RICH PRODUCTS PRETREATMENT FACILITY

Re: **Construction Storm Water Inspection at Rich Products Pretreatment Facility
Franklin County
Permit Number: 4GC03342 *AG**

Figure 1: Sediment basin requires modified outlet structure

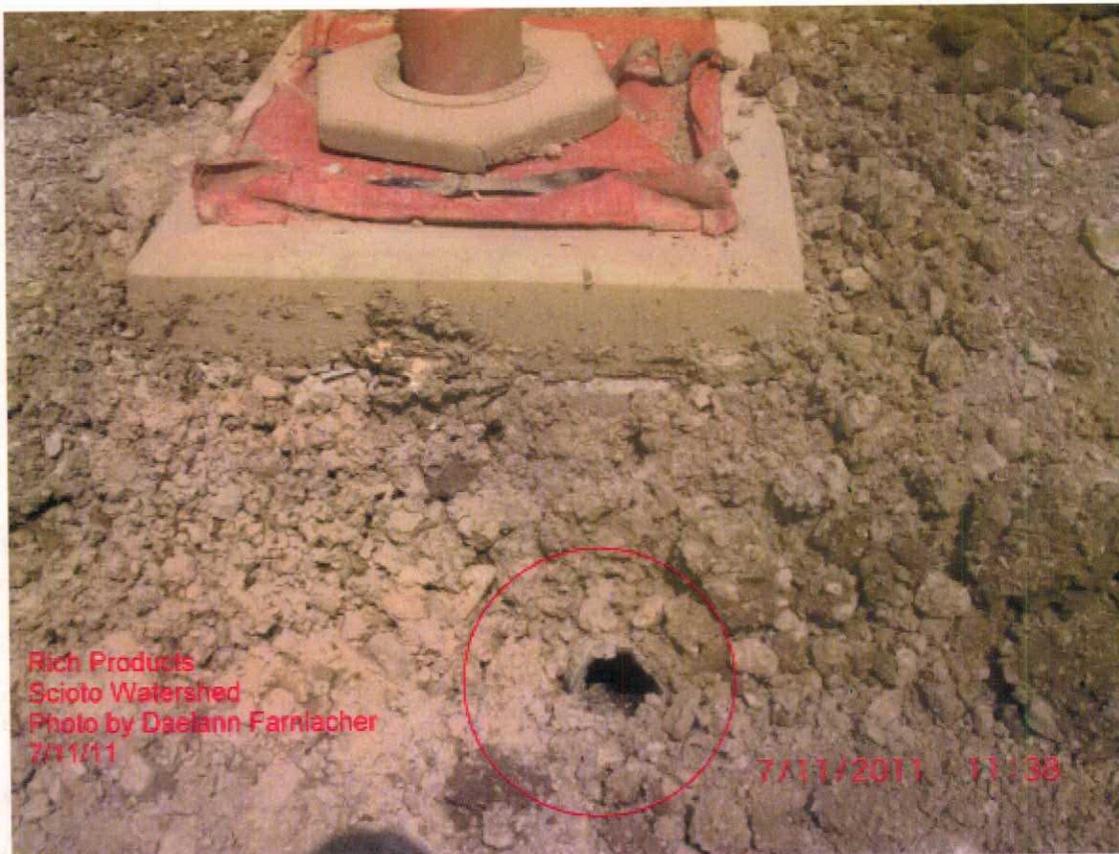
- During the inspection, our staff noted the sediment basin on site does not have an appropriate outlet structure (See Figure 1). Please install a modified sediment control outlet structure such as a temporary riser or skimmer within seven days from receipt of this letter to ensure compliance.
- The staff also noted a bypass into a storm sewer drain shown in Figure 2 which requires maintenance.
- It was noted that a storm sewer drain requires appropriate inlet protection to minimize the discharge of sediment into waters of the state (See Figure 3).
